REQUEST FOR INFORMATION **DATE:** August 05, 2016 **NO.:** RFI-236

Project Name: 15051-Webster University Interdisciplinary Science Building Project No.: 15051

Subject: Plumbing Roof Hydrant

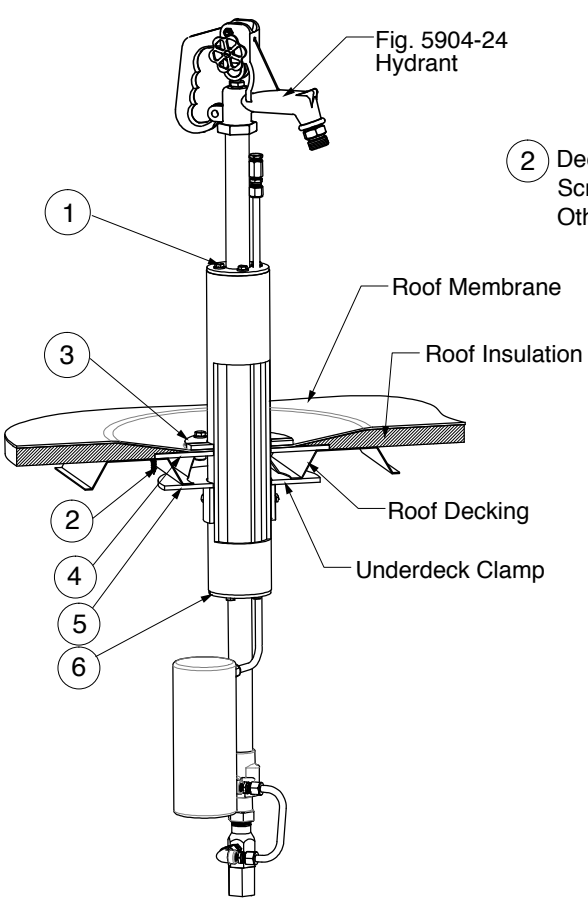
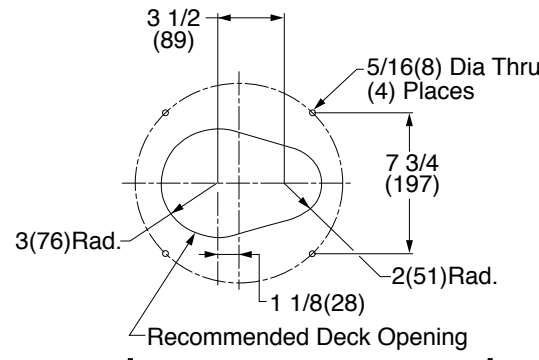
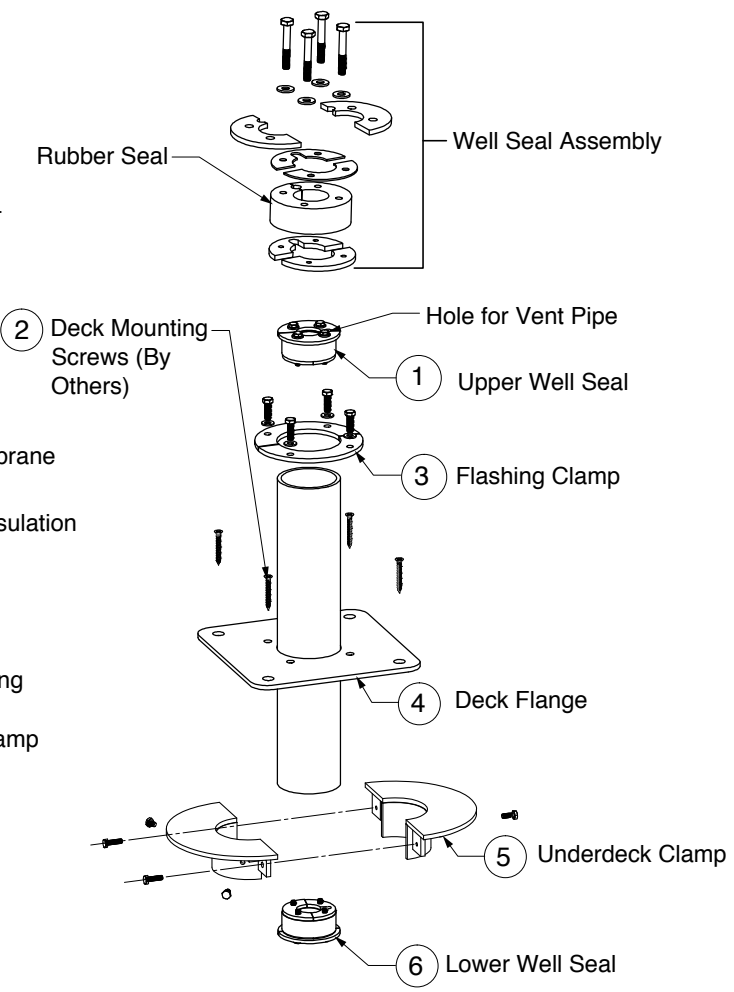
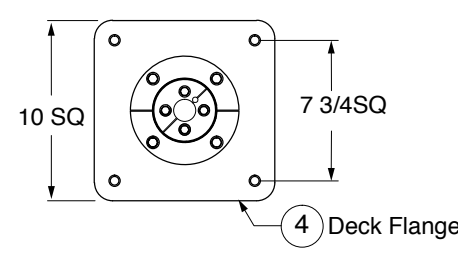
There are no roof hydrants shown on the plumbing roof plans. There is a hose bibb shown on P0104.A in S494A at the base of the ladder to the roof. Is there a need for a freeze-proof roof hydrant for rooftop maintenance of equipment in lieu of the hose bibb on level 04? If a 50ft or 100ft hose is connected to the hose bibb in level 04, there will be some residual water left in the hose that will spill out when it is disconnected.

The Owner has expressed a desire to have a roof hydrant, located at/near the roof-top equipment. The hose bibb and supply piping at the roof hatch is to be removed. A warning sign will be required stating water is not fit for drinking, or similar wording. Refer to the attached cut sheet for the basis of design, or an approved equal.
